ADDENDUM 01

Addendum to the drawings and specifications for:
Kendall County – Emergency Medical Services Station No. 3

EMERGENCY MEDICAL SERVICES STATION NO.3

10.06.23

Date: Oct 05, 2023, 4:06pm User: ID: RMedina File: W:\Work\C-1623 Kendall County EMS Station No. 3 - BPA\Design\Civil\Construction Documents\C-13 CIVIL DETAILS.dwg

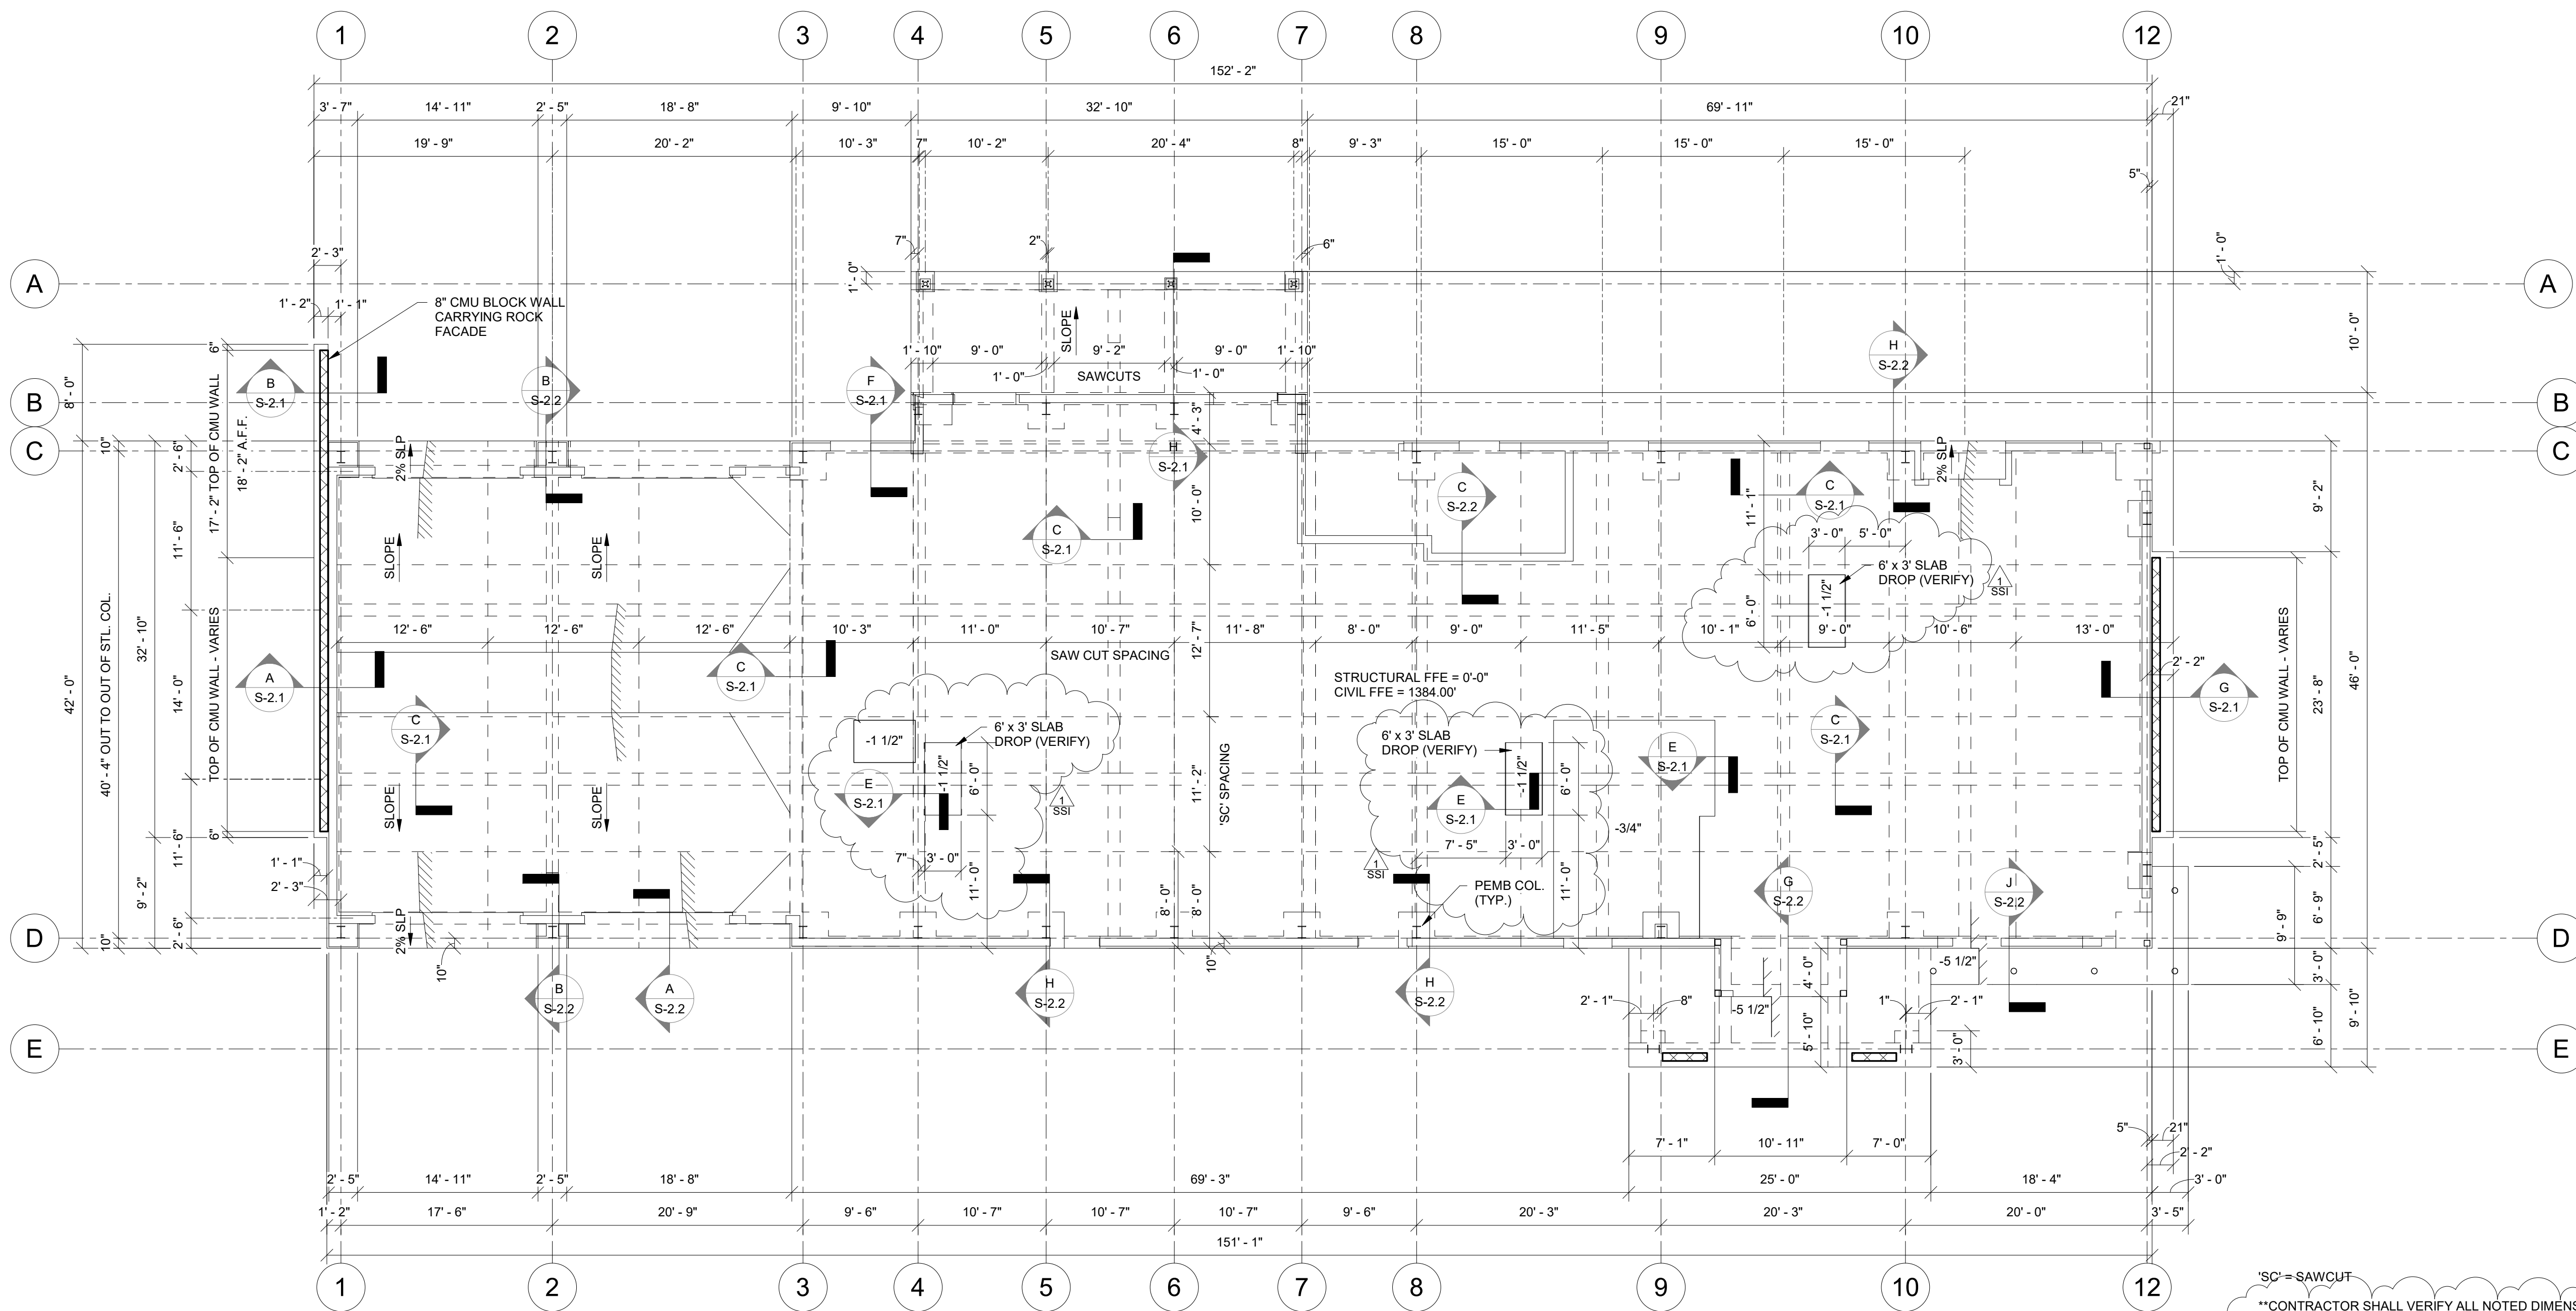
- Item 1. Detail 4 Pavement Section – Remove raw subgrade heavy duty section.

1 ELECTRICAL POWER PLAN
1/8" = 1'-0"

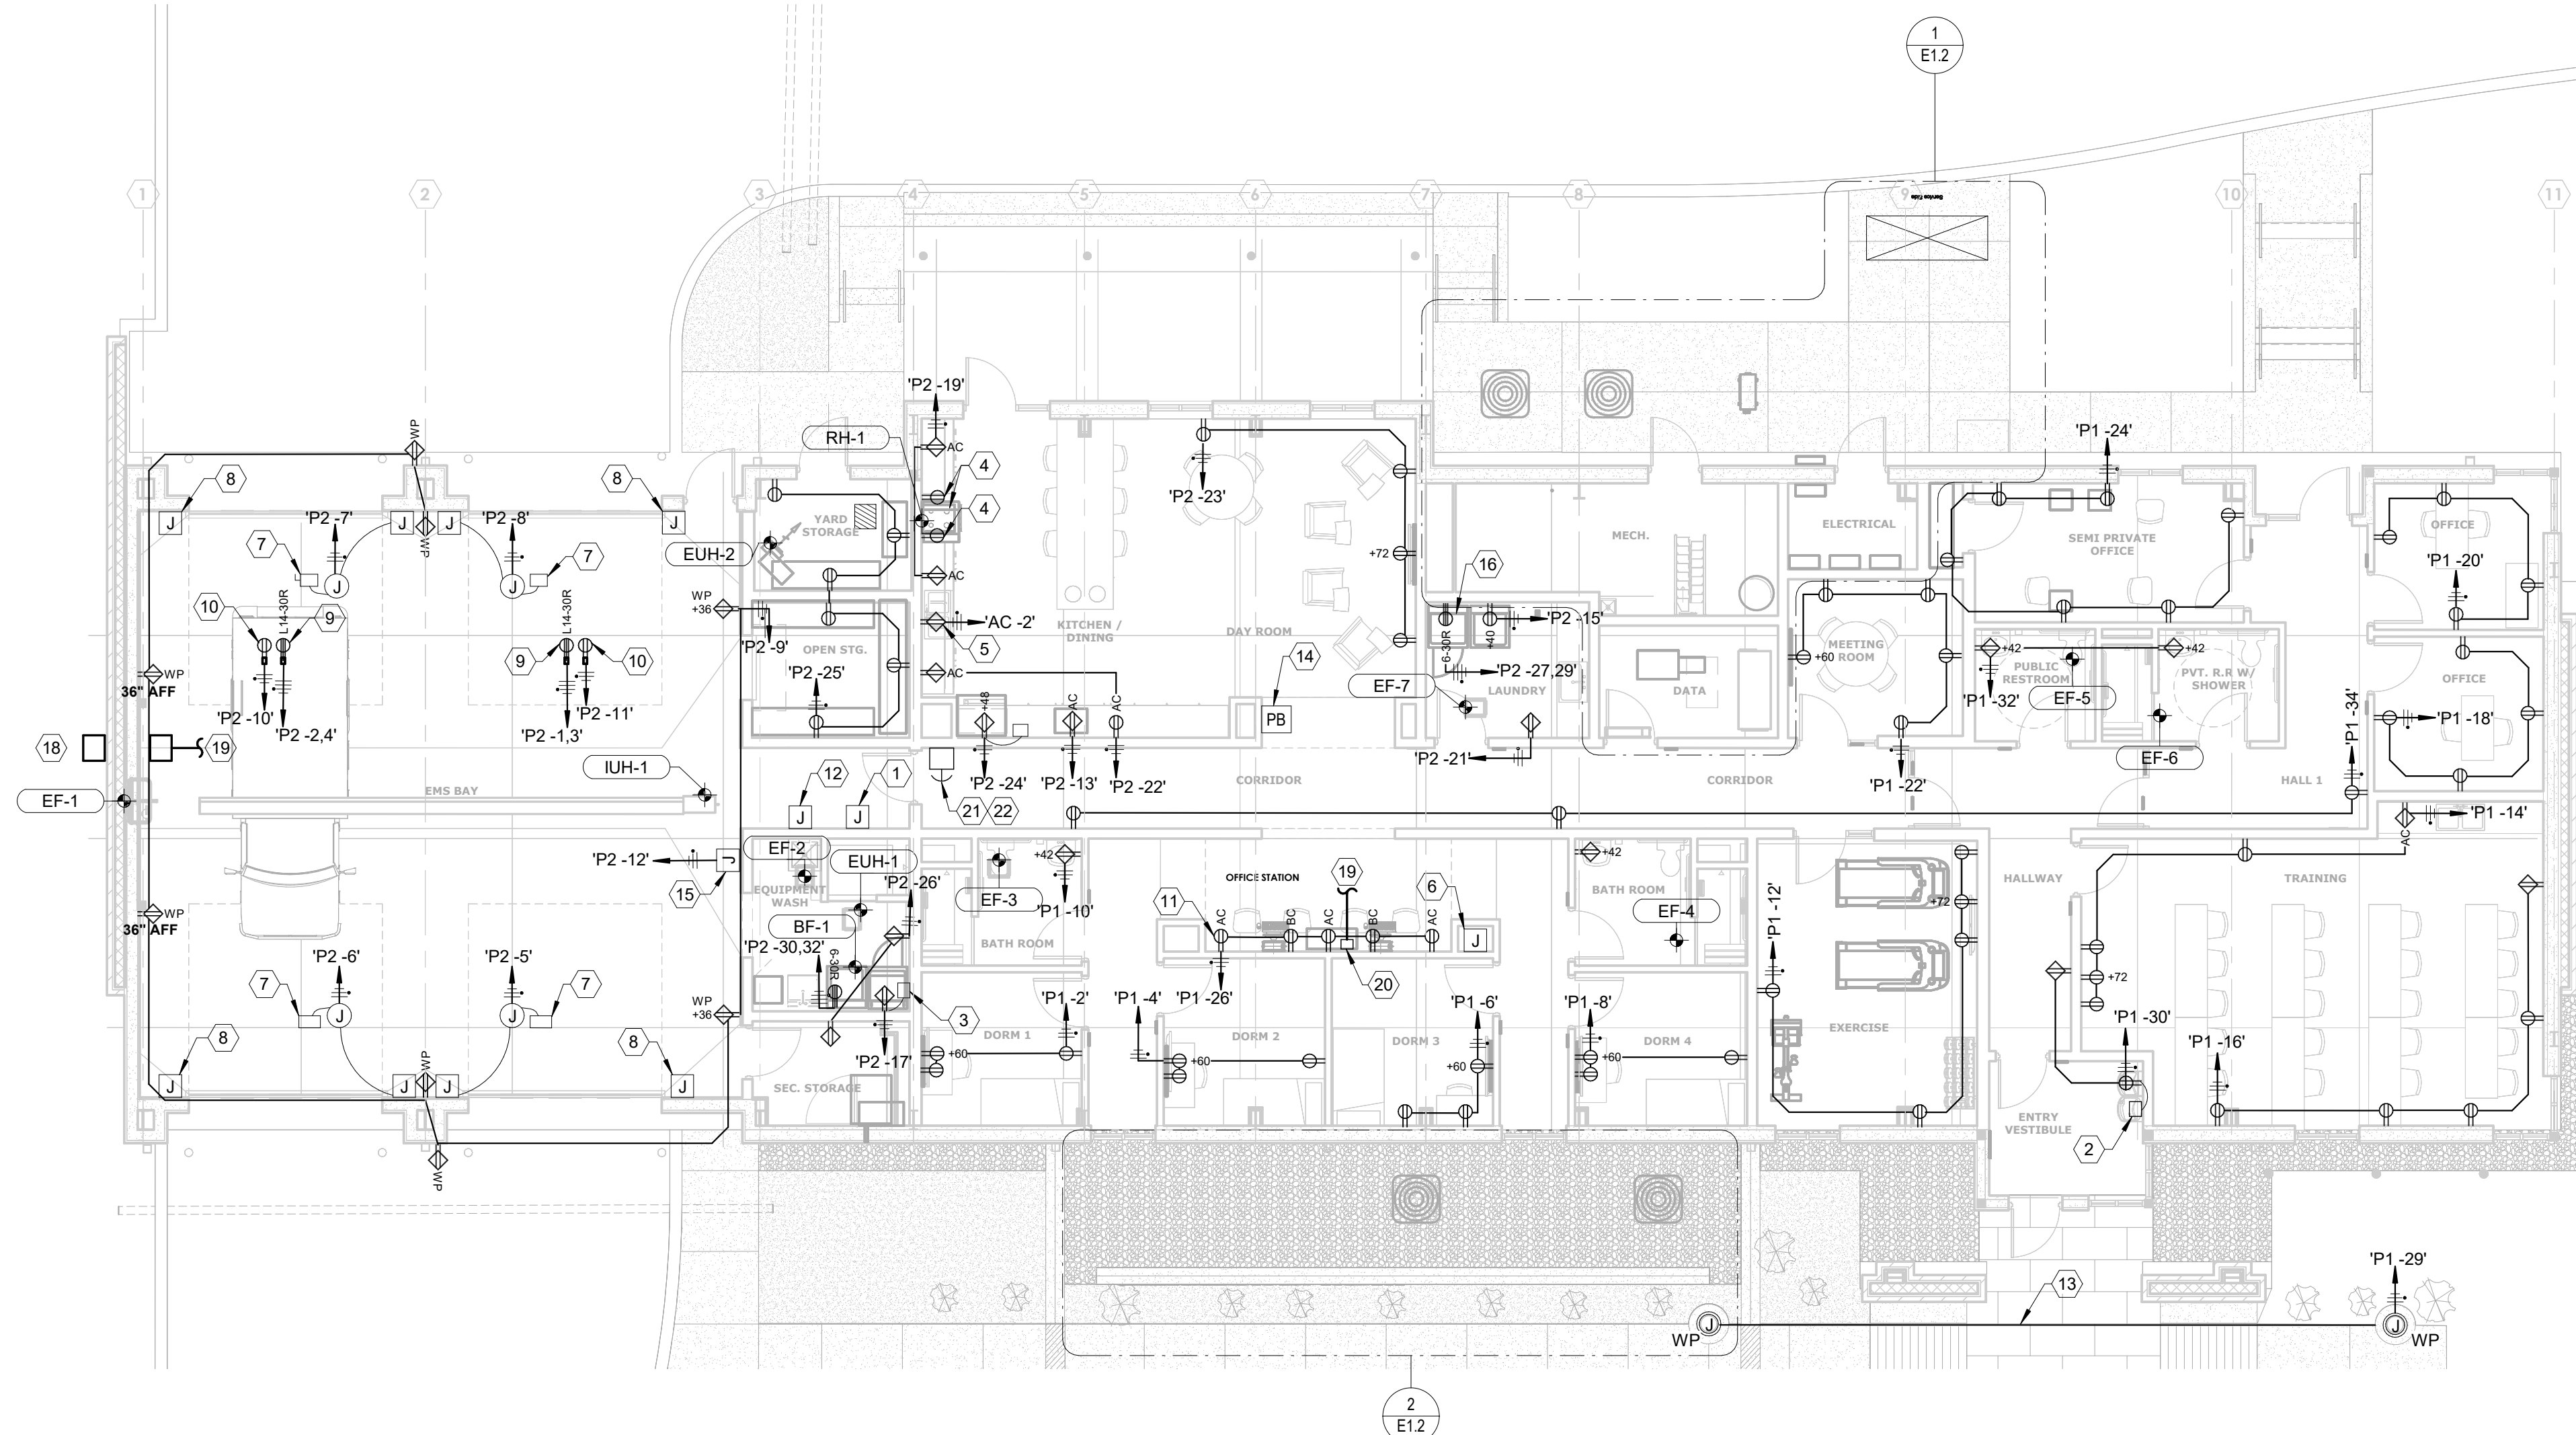
- Item 1: Removed CF circuits from power plan and added to lighting plan Sheet E2.1.
- Item 2: Added Keyed Notes 18 - 22 to Detail 1 Keyed Notes. Notes reflected onto Detail Power Plan Sheet.

- Item 1: Removed CF circuits from power plan and added to lighting plan Sheet E2.1.
- Item 2: Added Keyed Notes 18 - 22 to Detail 1 Keyed Notes. Notes reflected onto Detail Power Plan Sheet.
